Report: TAB Report
Function: Test, Adjust, & Balance
Date: 05/29/2025
Completed By: National TAB

PROJECT
05-26-25 CAVA WARWICK, RI

Issue List

Issue Name : 1. RTUs On Incorrect Curbs

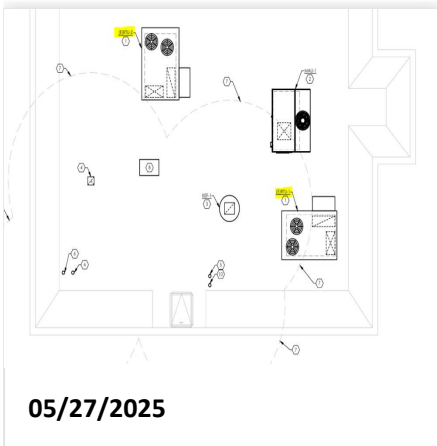
Description : The "48FCD09" unit is serving the Dining Area and the "48FCDN12" unit is serving the Kitchen. Per the mechanical plans, the larger unit is supposed to serve the Dining Area. To achieve proper cooling of the space, these units will need to be swapped.

- **05/27/2025 National TAB - Stephen Tassinaro**
 - Currently both units will be balanced to 400CFM/Ton respectively. This will not match the designs shown on the mechanical plans since there is now 4000CFM in the kitchen instead of 3400CFM. And 3400CFM in the dining room, instead of the original 4000CFM. All diffusers will be proportionally balanced.

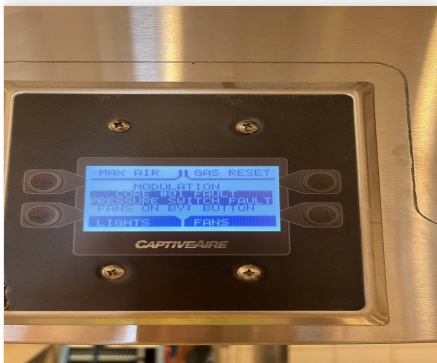
Issue Name : Grease Duct Not Secured to Curb
Description : Duct top plate flanges to the edges of the curb, but it is not secured. This allows for movement of the grease duct and grease will accumulate.
Created By : National TAB **Assigned To :** National TAB - Will Turnbough
Status : Open
Priority : Medium **Asset Tag :**
Originated Date : 05/29/2025 - Stephen Tassinaro - National TAB

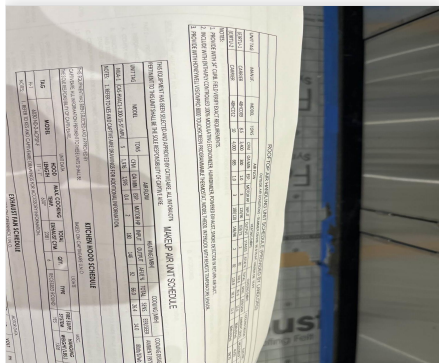
Issue Name : Hood "Core #01 Fault"
Description : The kitchen hood HMI is displaying "Core #01 Fault". This did not effect the balancing of the hood.
Created By : National TAB **Assigned To :** National TAB - Will Turnbough
Status : Open
Priority : InfoOnly **Asset Tag :**
Originated Date : 05/27/2025 - Stephen Tassinaro - National TAB
